SUNDRY NOTICES AND REPORTS ON WELLS

Mewbourne Oil Company requests a variance to perform BOP break testing and offline cementing on the following wells:

PECOS DISTRICT
DRILLING CONDITIONS OF APPROVAL

BOP Break Testing Variance

Figure 1. BOP diagram

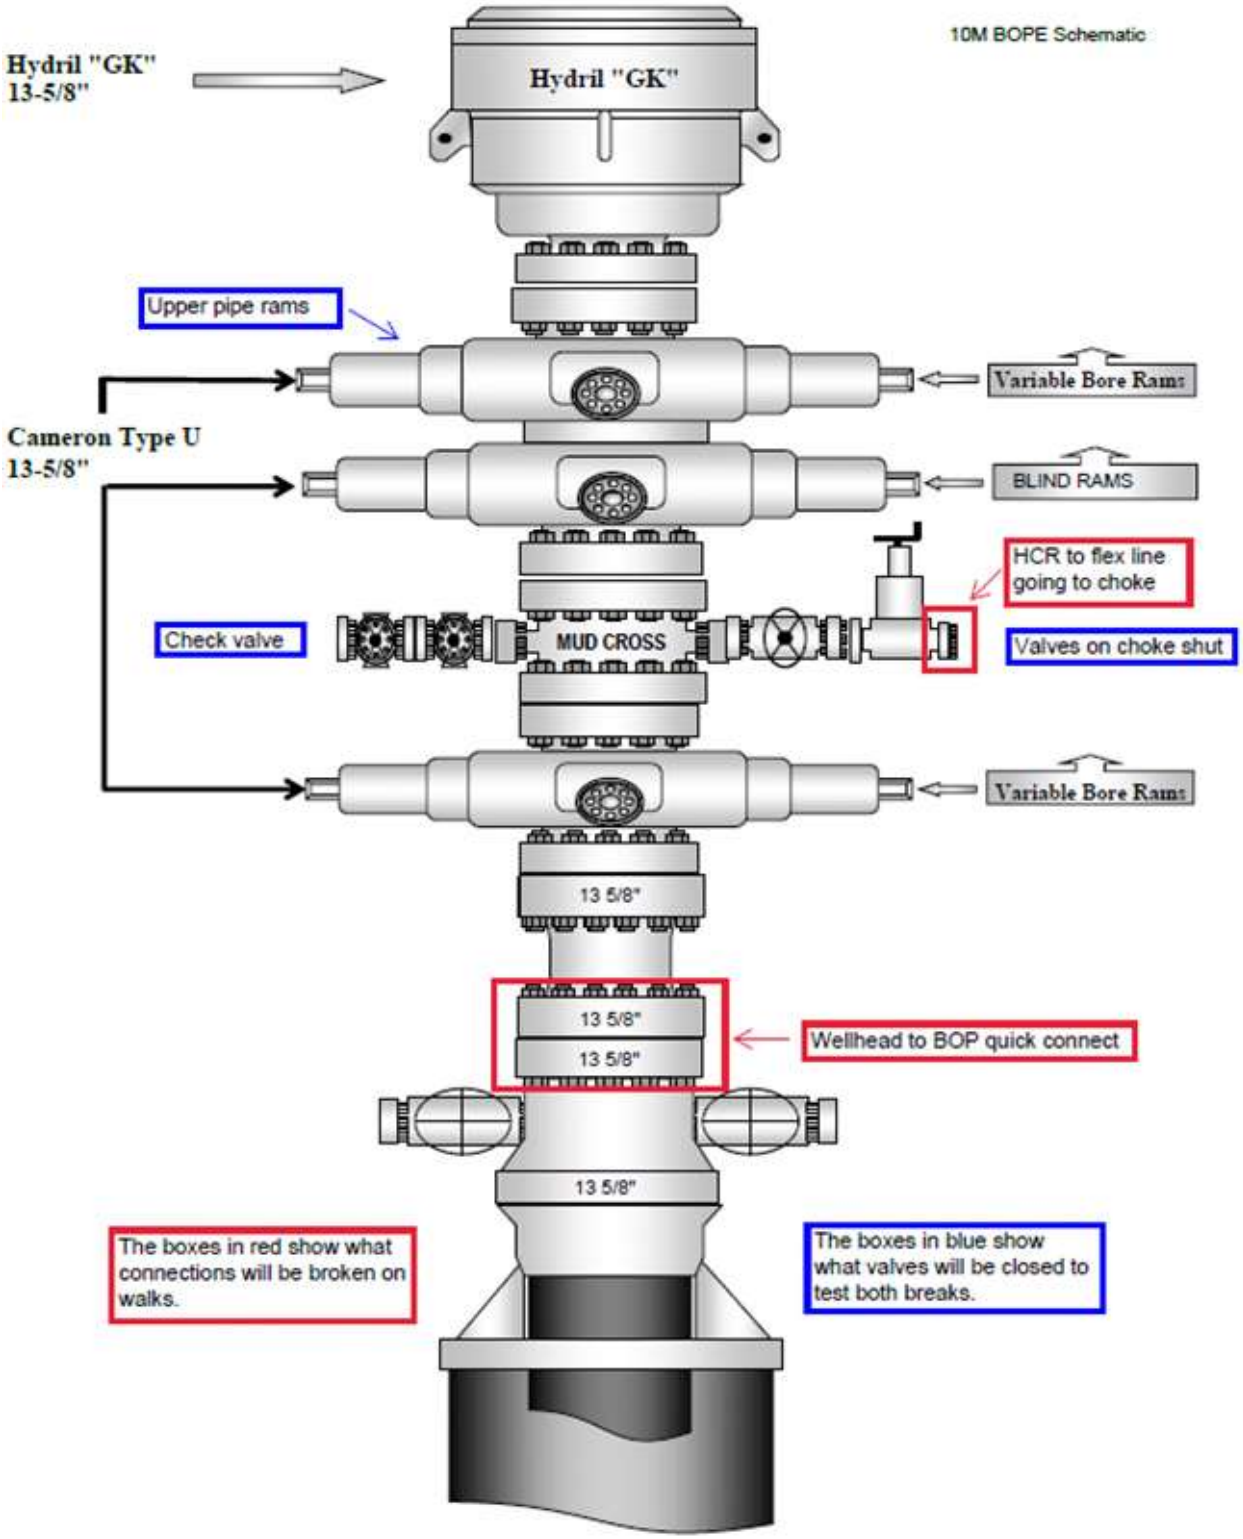
2. After the well section is secured and the well is confirmed to be static, the BOP will be disconnected from the wellhead and walked with the rig to another well on the pad. Two breaks on the BOPE will be made (Fig. 1).

- Connection between the flex line and the HCR valve
   - Connection between the wellhead and the BOP quick connect (Fig. 5 & 6).
3. A capping flange will be installed after cementing per wellhead vendor procedure & casing pressure will be monitored via wellhead valve.

9. A test will then be conducted against the upper pipe rams and choke, testing both breaks (Fig. 1 & 2).
10. The test will be held at 250 psi low and to the high value submitted in the APD, not to exceed 5000 psi.

Figure 1. Cactus 13 3/8" 5M offline cementing tool. Pressure rating limited by the lesser of 5M tool rating or the 13 3/8" pup joint and casing.

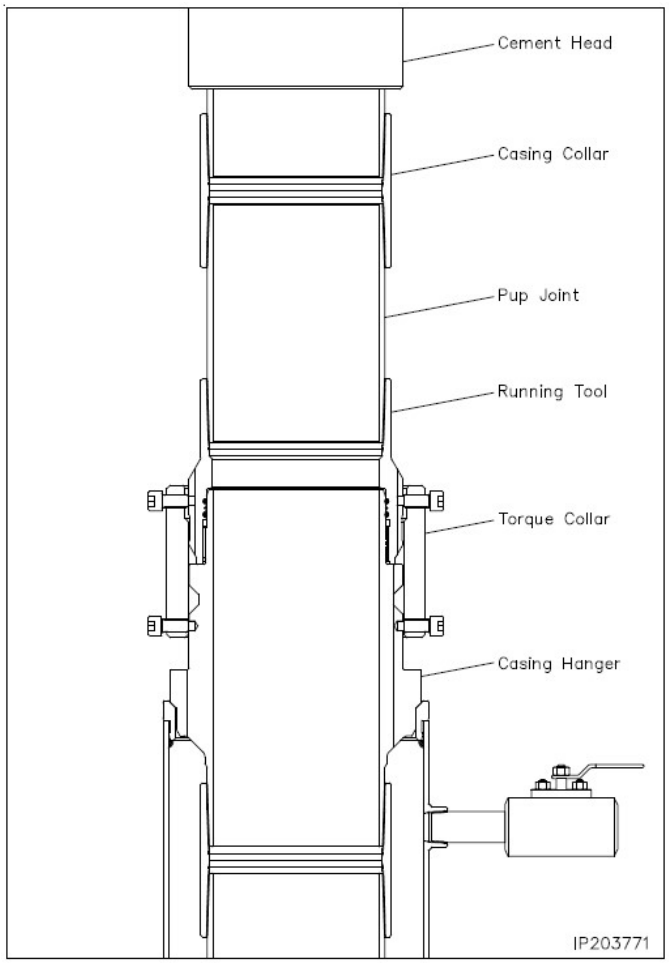
9. Make up offline cement tool with forklift per wellhead manufacturer (Fig. 1 & 2).
10. Make up cement head on top of offline cement tool with forklift.

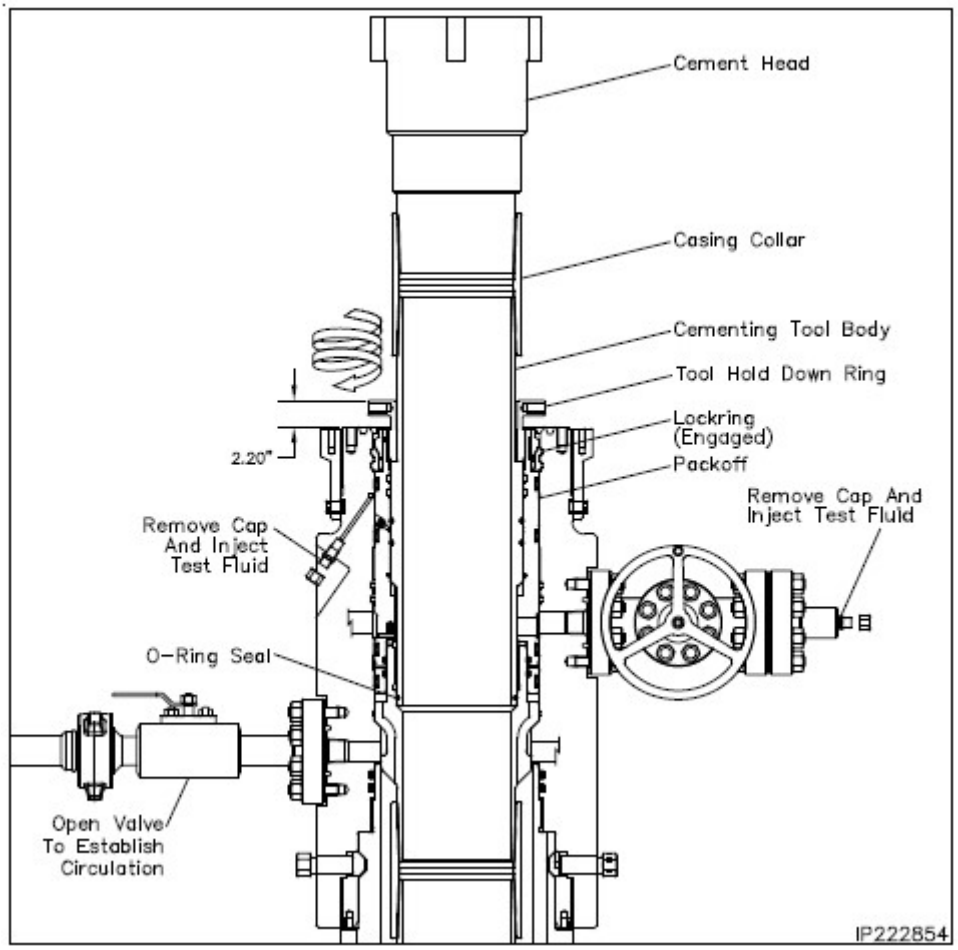
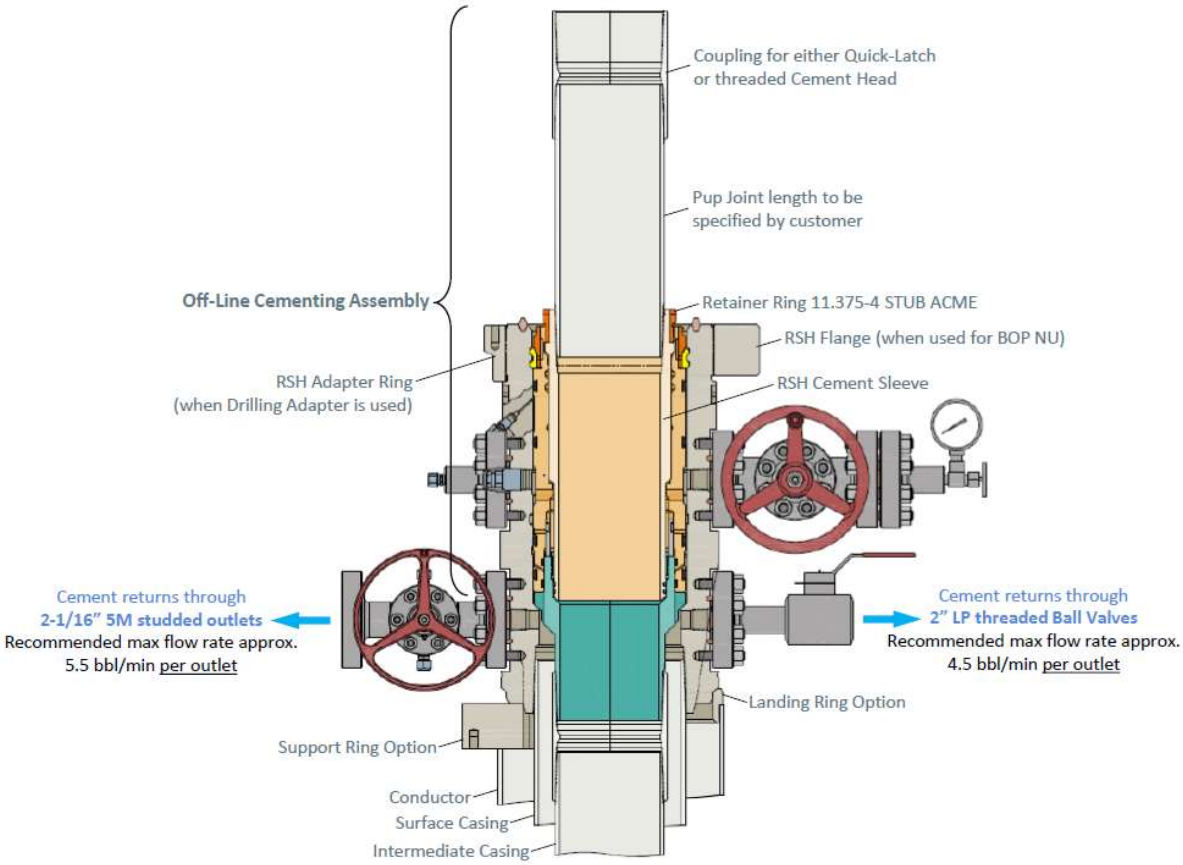
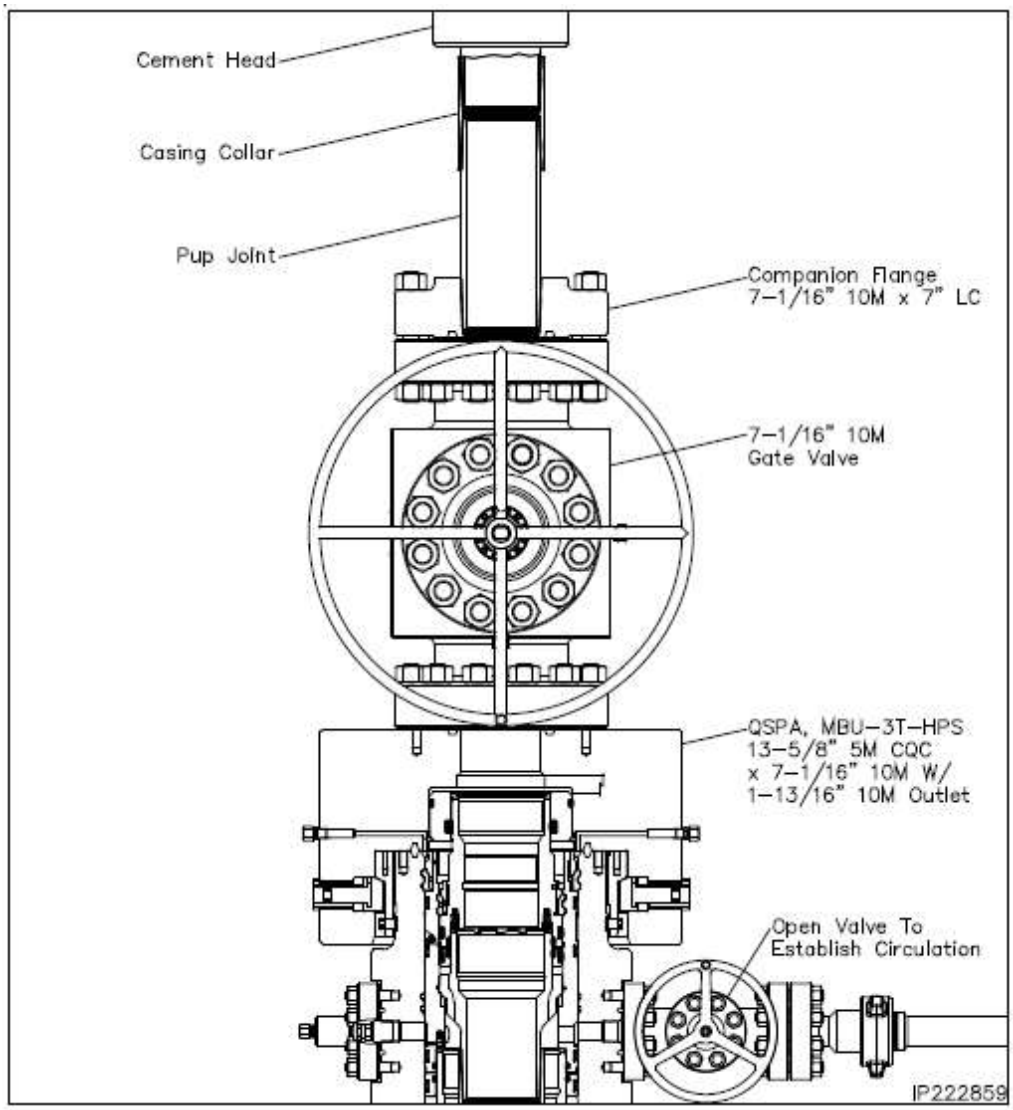
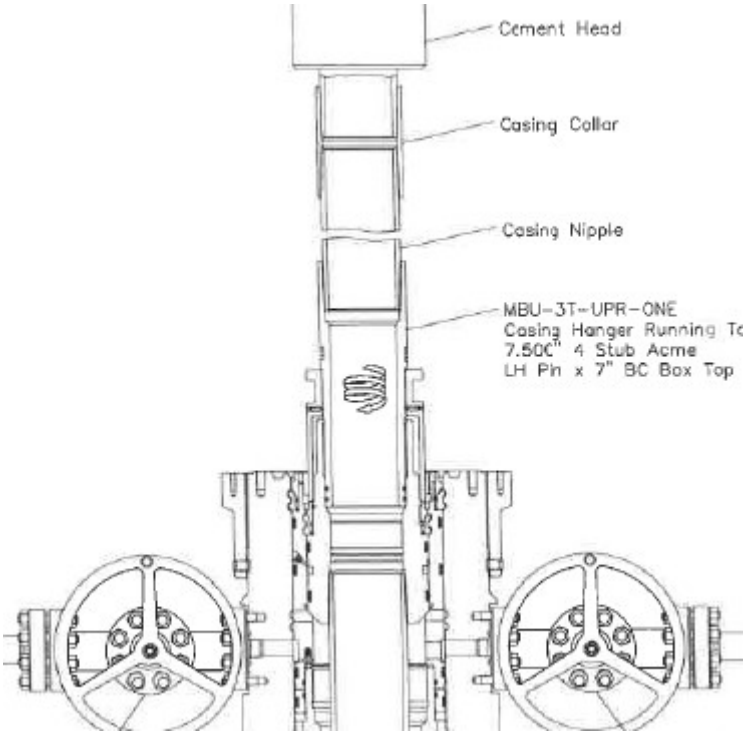
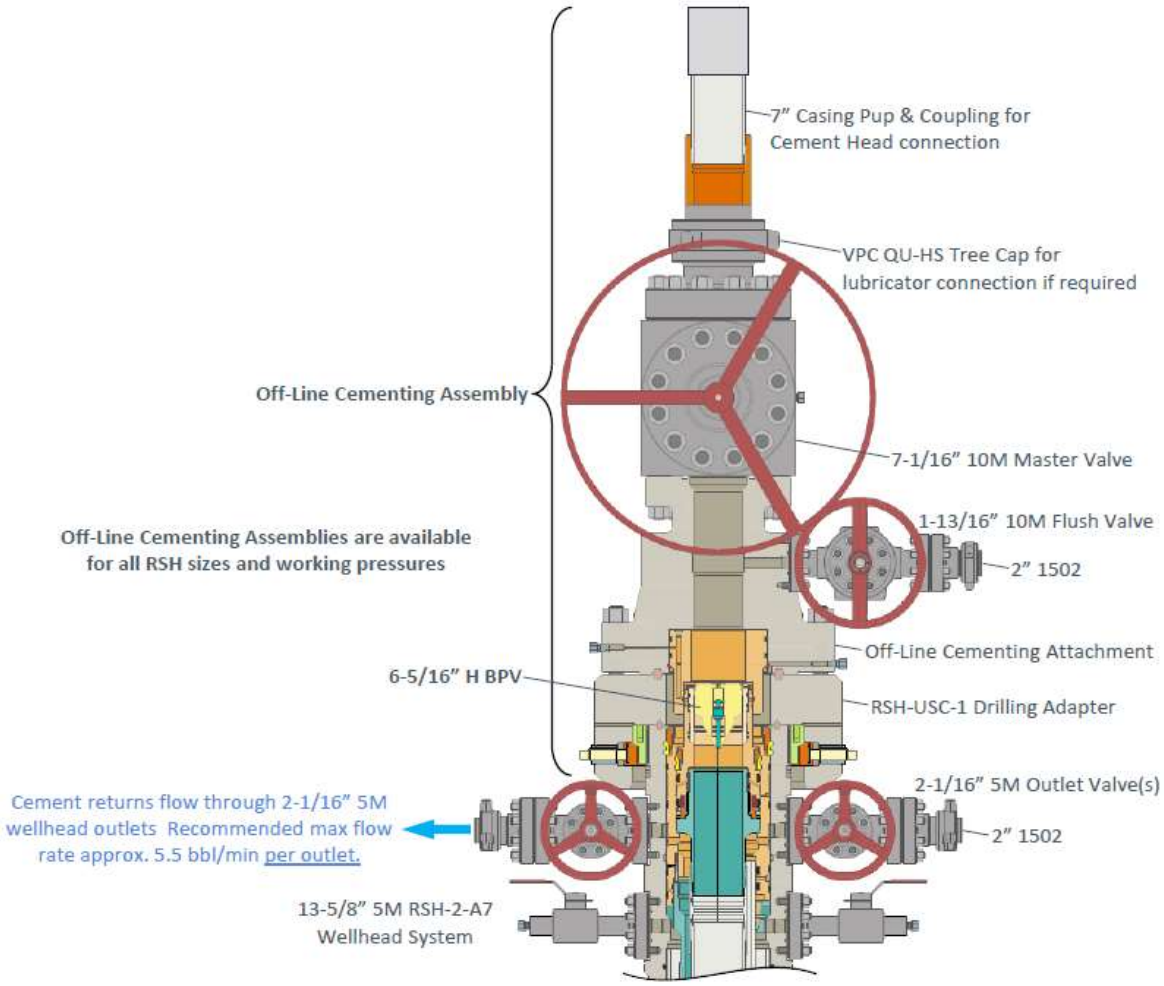
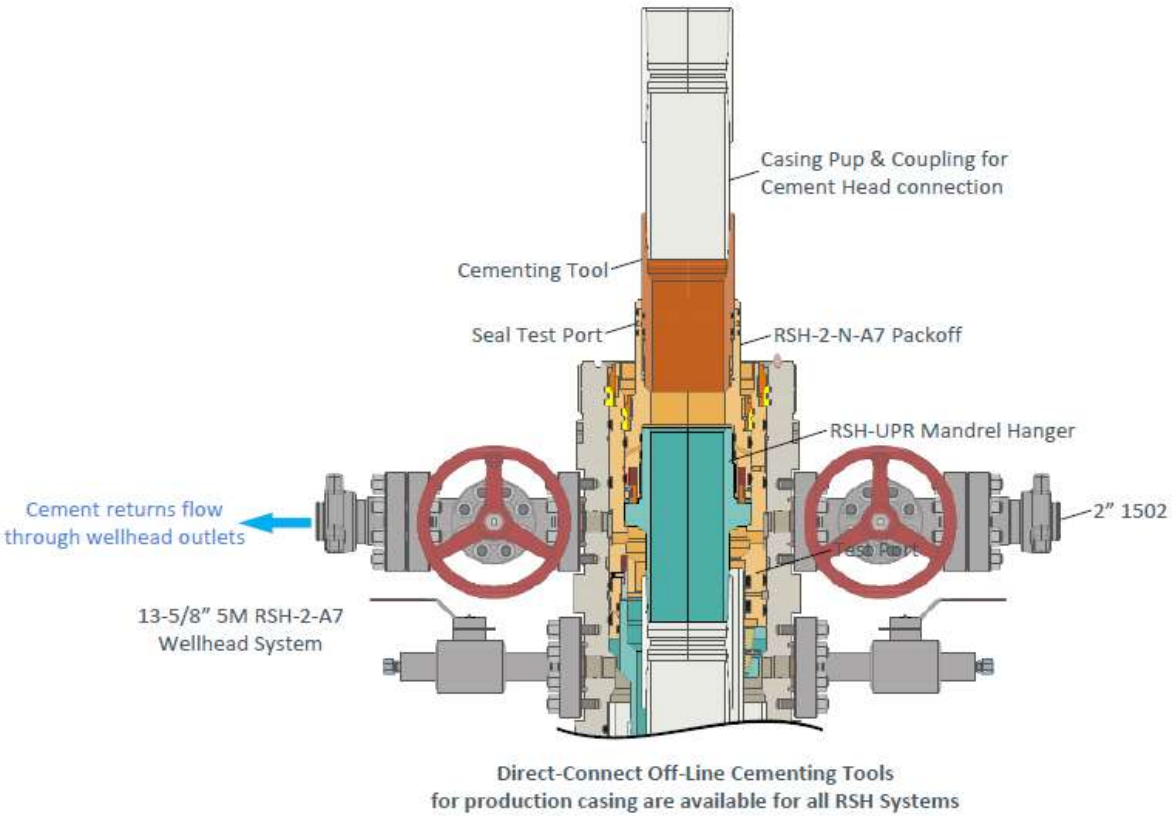
10. Make up offline cement tool using forklift per wellhead manufacturer (Fig. 3 - 8).
11. Make up cement head on top of offline cement tool.
12. Commence cement operations.

Figure 9. Five valve 15k choke manifold.

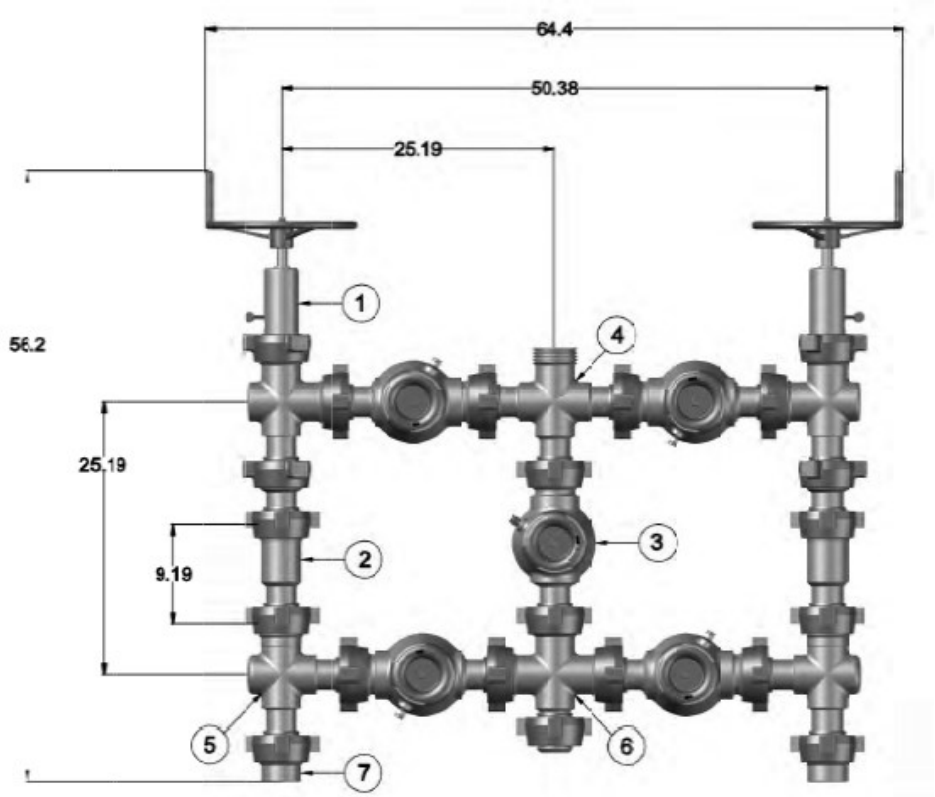
- Pressure build up in annulus before cementing
  - Contact BLM if a well control event occurs.
  - Rig up 3rd party pump or rig pumps to pump down casing and kill well.
  - Returns will be taken through the wellhead valves to a choke manifold (Fig 9 & 10).
  - Well could also be killed through the wellhead valves down the annulus.
